FRONT OVERVIEW

BACK OVERVIEW

FIRST FLOOR PLAN
 PROPOSED RENOVATION

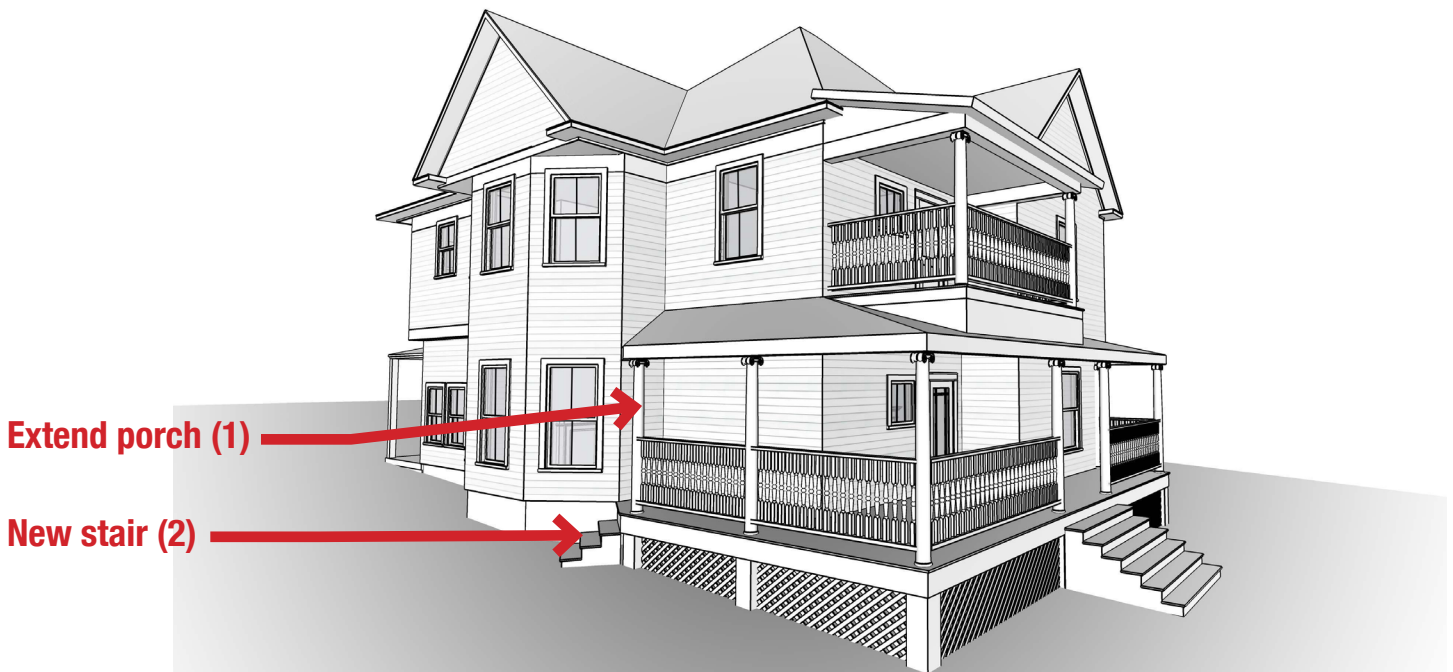
- 1** Remove non-original, partially open-air staircase between the front porch and the upper porch. Staircase will be replaced with new interior stair. Patch, repair, or provide new wood siding where stair and doorways are removed. Original porch beam at top of wall will be preserved. A new column with scamozzi capital and new wood railing will be built to match the existing porch columns and railings.
- 2** Remove exterior concrete basement stairs, wood door at bottom of stairs, and small metal roof above stairs. Remnants of the original interior basement stair were discovered and a new stair will be constructed in that location. All damaged siding to be patched and repaired in-kind. Add wood steps from the front porch to the side yard in this location.

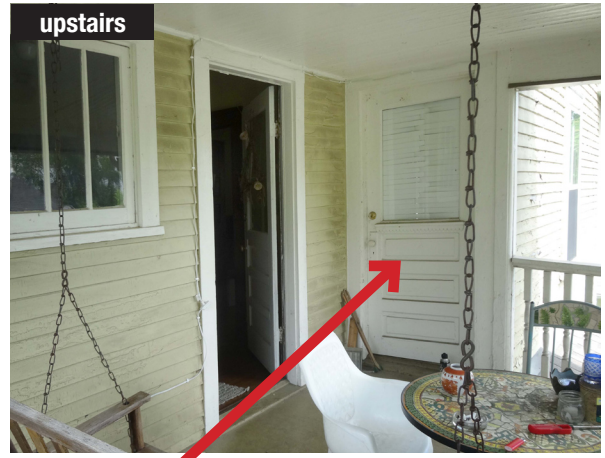
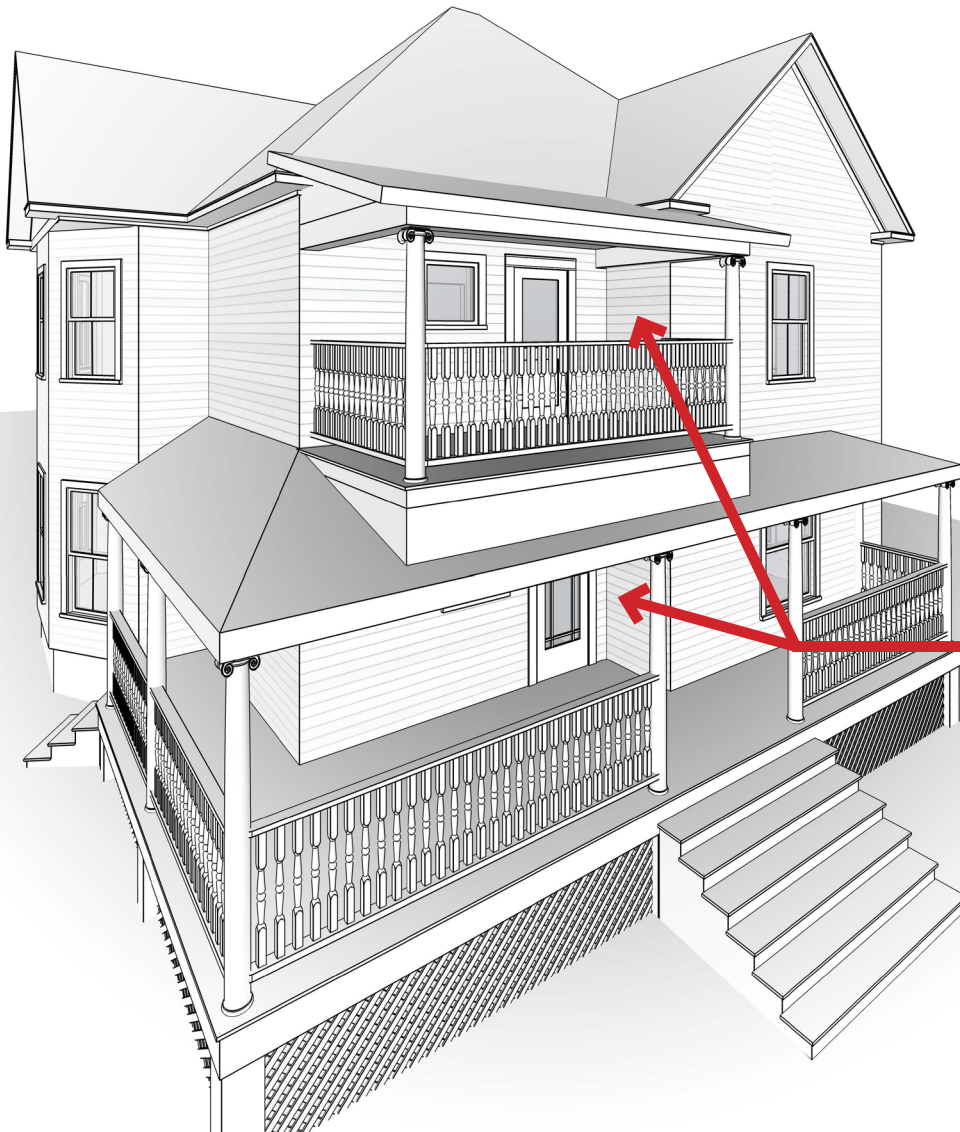
3,4 Remove non-original doors to former apartments upstairs and down. Openings will be filled with wood siding to match existing.

Remove

Fill openings with wood siding to match existing

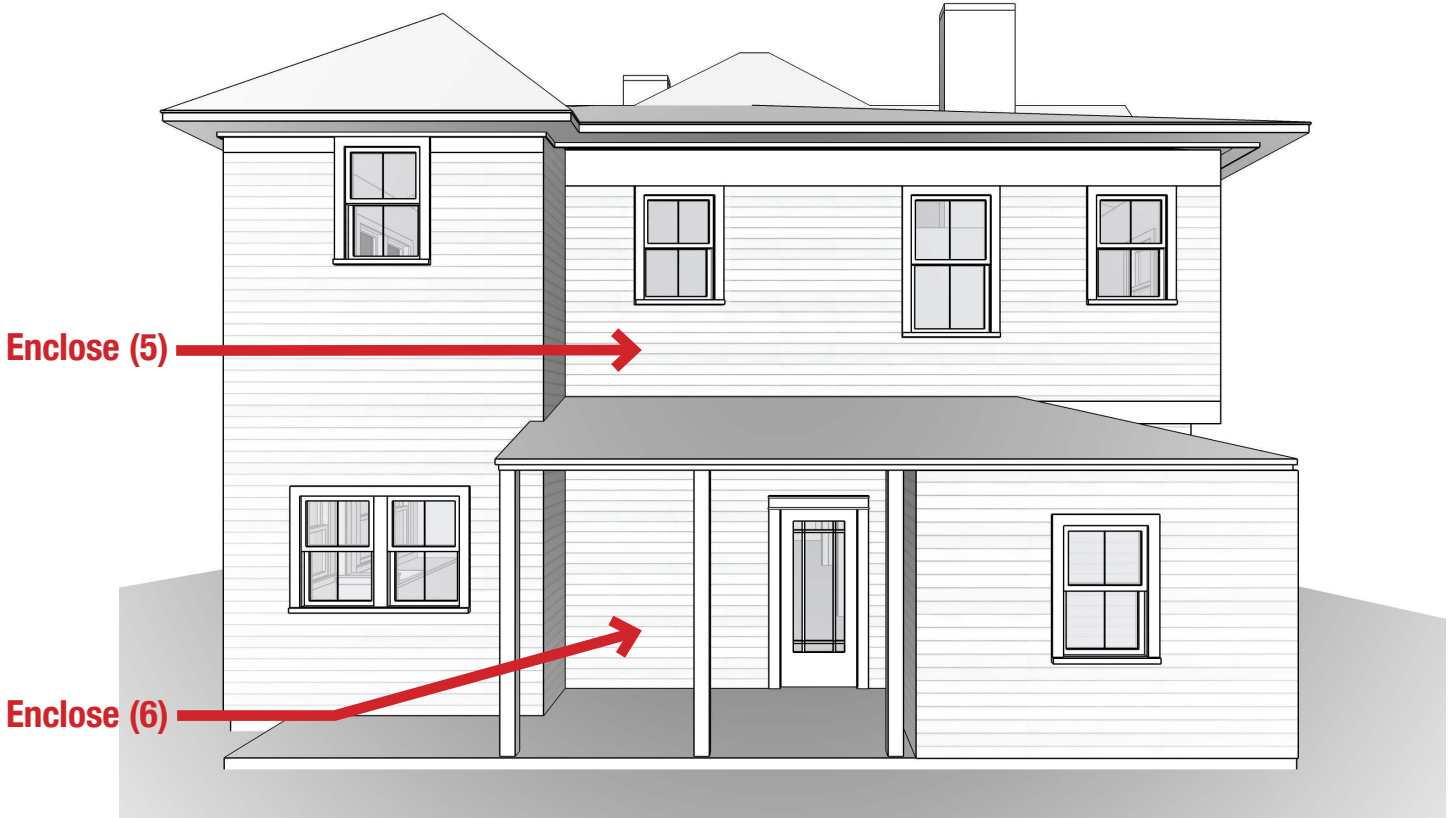
5,6 Partially enclose porches, upstairs and down. New walls will have wood siding to match existing.

7,8 (7) Remove upper deck and staircase - patch porch roof below as required. (8) Remove non-functioning, partial staircase downstairs.

9 Remove single, double hung, vinyl window facing the alley and replace with new wood, double hung, 2-over-2 window to match original windows.

10 Replace existing back door with door salvaged from front, exterior stair (matches front door).

11 Remove non-functioning door. Opening will be filled with wood siding to match existing.

12 Remove single, double hung, 2-over-2 window facing the alley and replace with new pair of wood, double hung, 2-over-2 windows. Move single window from downstairs to upstairs back wall.

DOUBLE WINDOW

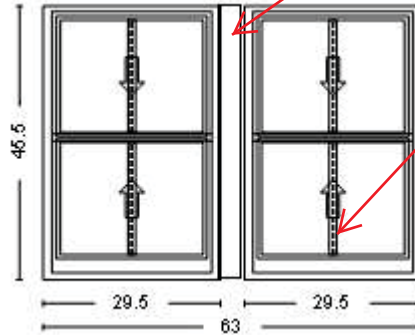
center mullion will be 4" to match adjacent existing double windows

Pella's "Integral Light Technology Grille" (1 1/4" size) will be used. Wood grilles are permanently bonded to the interior and exterior of the glass, with a spacer bar between the glass panes (called "Simulated Divided Light" by other manufacturers).
